**Re: Lincoln Complex Building M Renovations
915 Locust St.
Traffic Circulation Layout
Engineer's/Architect's Stamp dated 8-19-15 (K15-D047B)**

RE: Lincoln Complex Building M Renovations
Traffic Circulation Layout
Engineer's Stamp Dated 7-31-15 (K15-D047)

OVERALL TRAFFIC
CIRCULATION
LAYOUT

C-104A

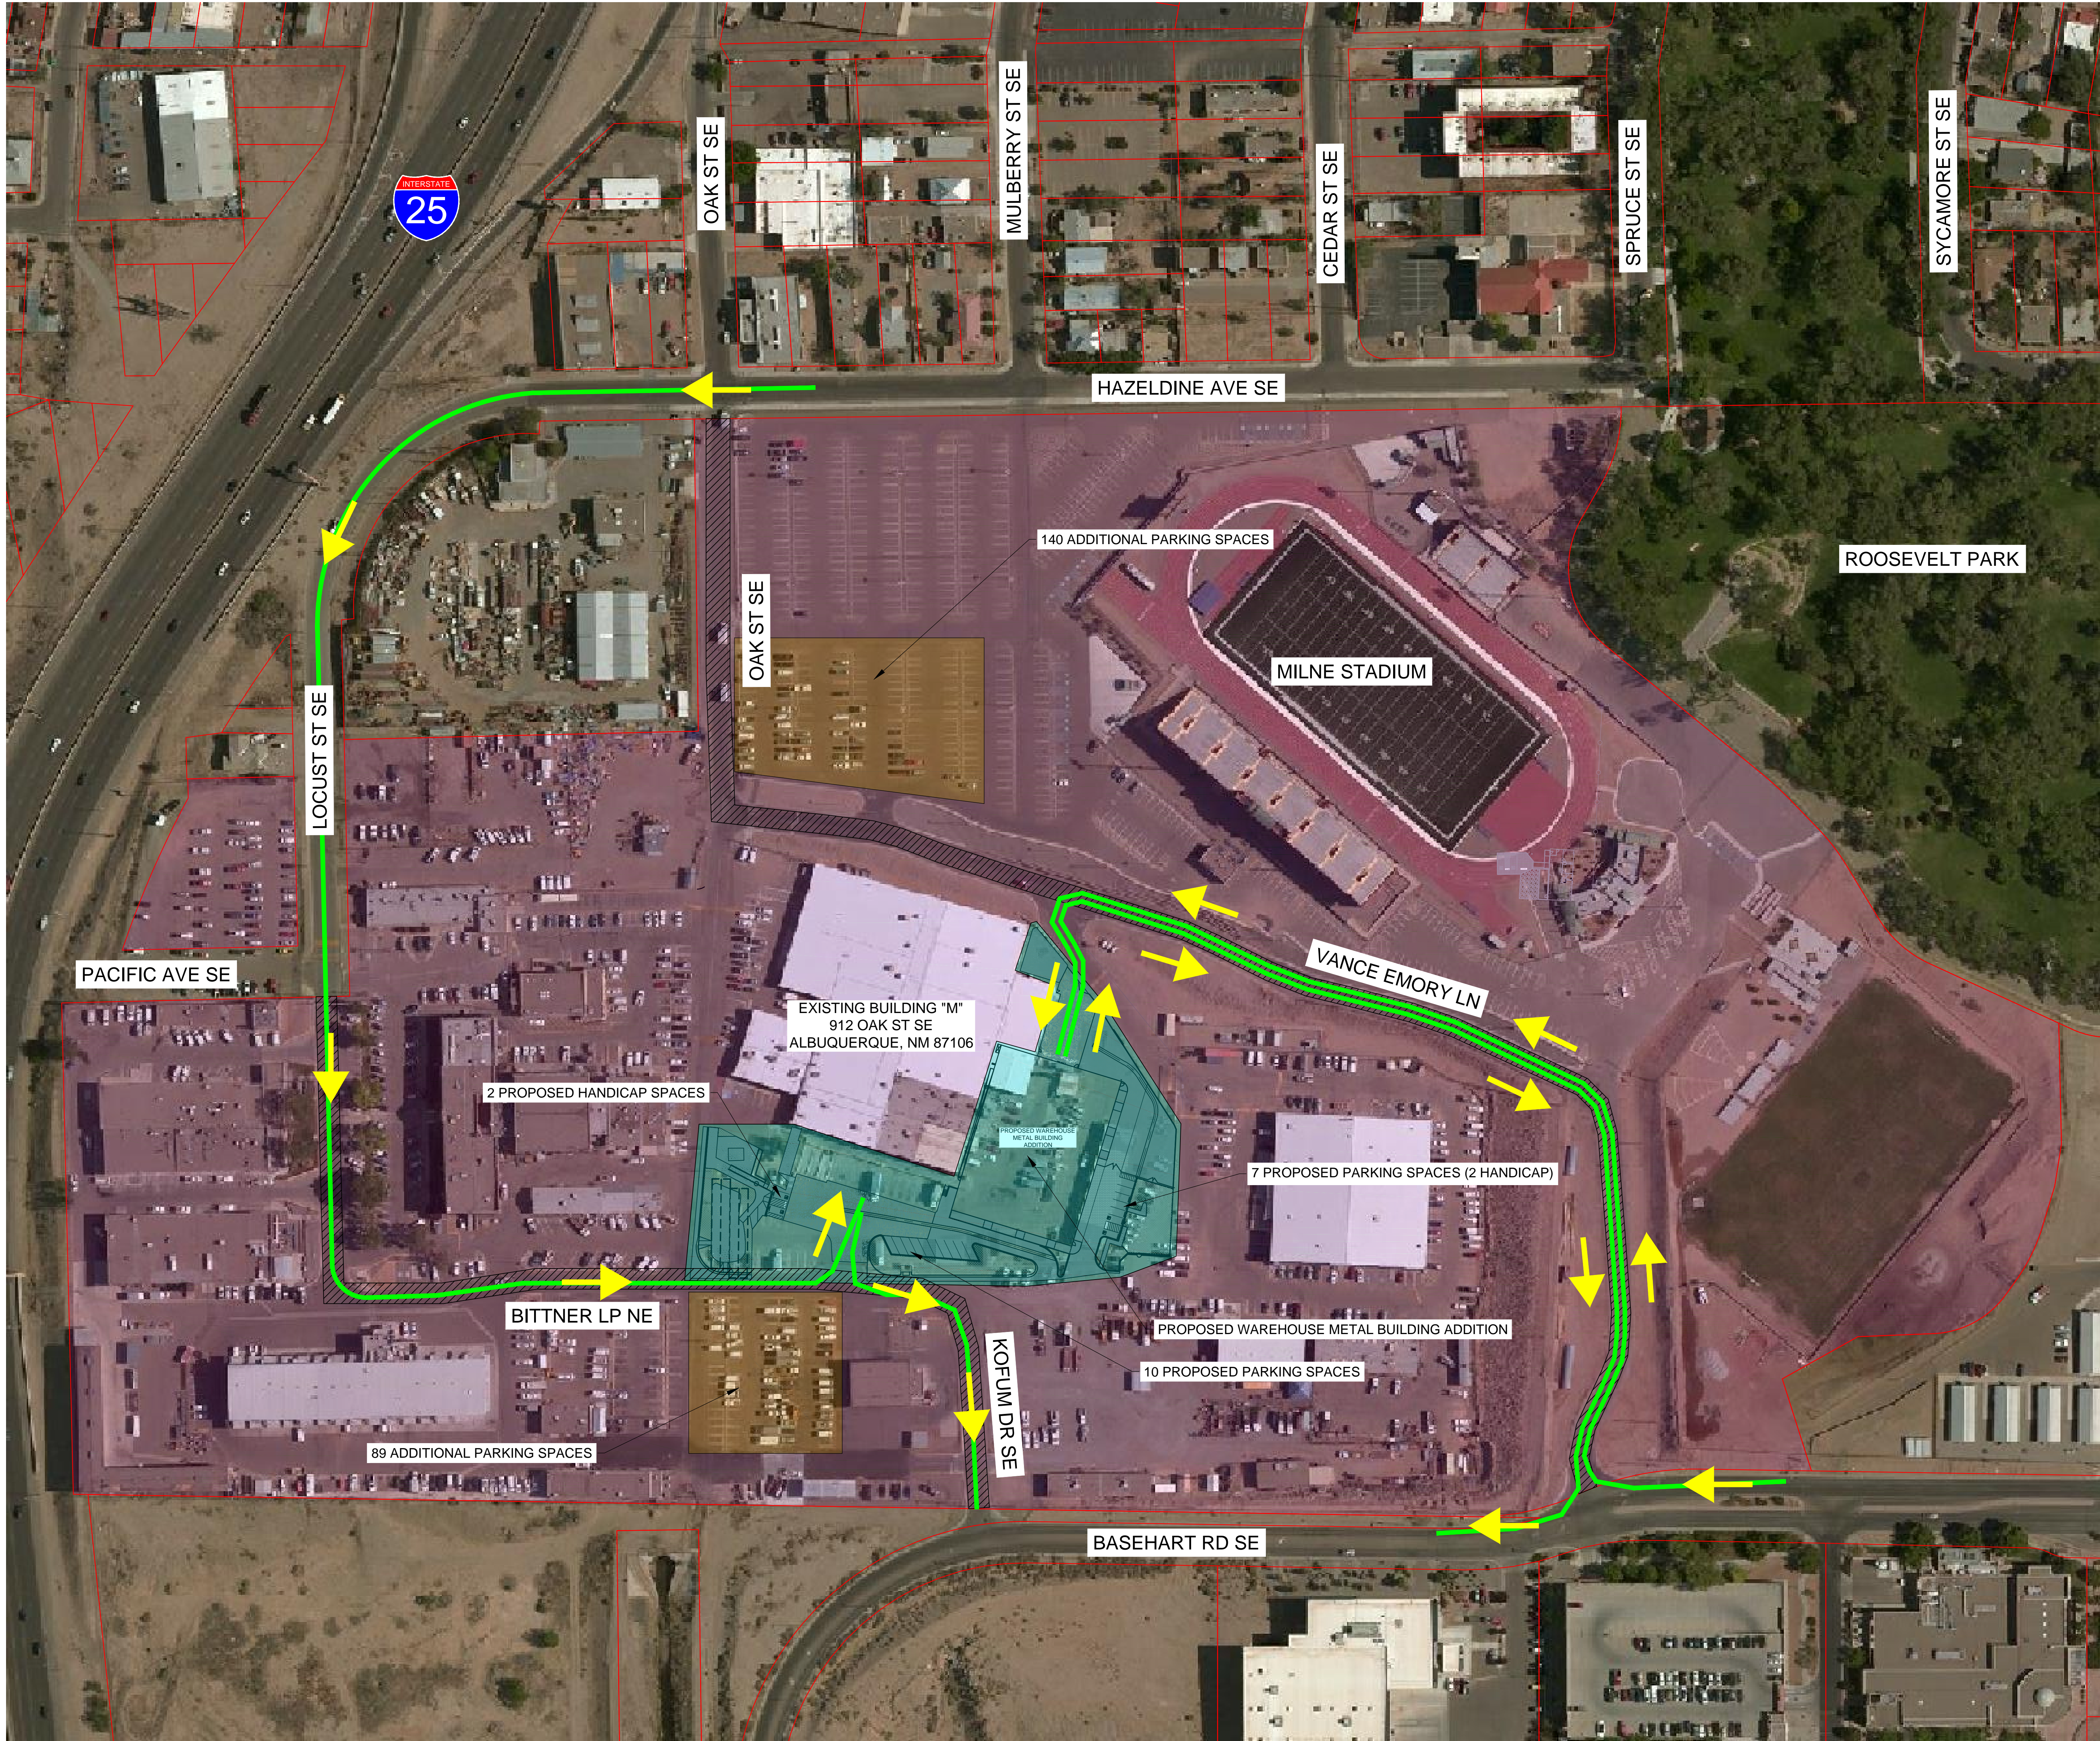
3. Clarify the extents of the current phase. Please detail existing and proposed buildings, parking spaces and public or private road ways. *Sheet C-104-A shows the extents of the current phase within Lincoln Complex. Existing features are shown/labeled and are faded back. Public and private road ways have been labeled.*

14. Design delivery vehicle route needs to be shown. **The design delivery route is shown on sheet C-104A**
15. Service vehicle and/or refuse vehicle maneuvering must be contained on-site; provide a copy of a refuse approval. **Lincoln Complex encompasses a large area and has multiple uses and the service vehicle and/or refuse vehicle location is outside of the project area but contained within APS property.**
16. Please provide a sight distance exhibit (see the *Development Process Manual, Chapter 23, Section 3, Part D.5 Intersection Sight Distance*). Please show this detail for entrances off of Vance Emory Ln. and roadway on the south side of project site. **Vance Emory Lane is a private APS road and no improvements are being made at this time.**
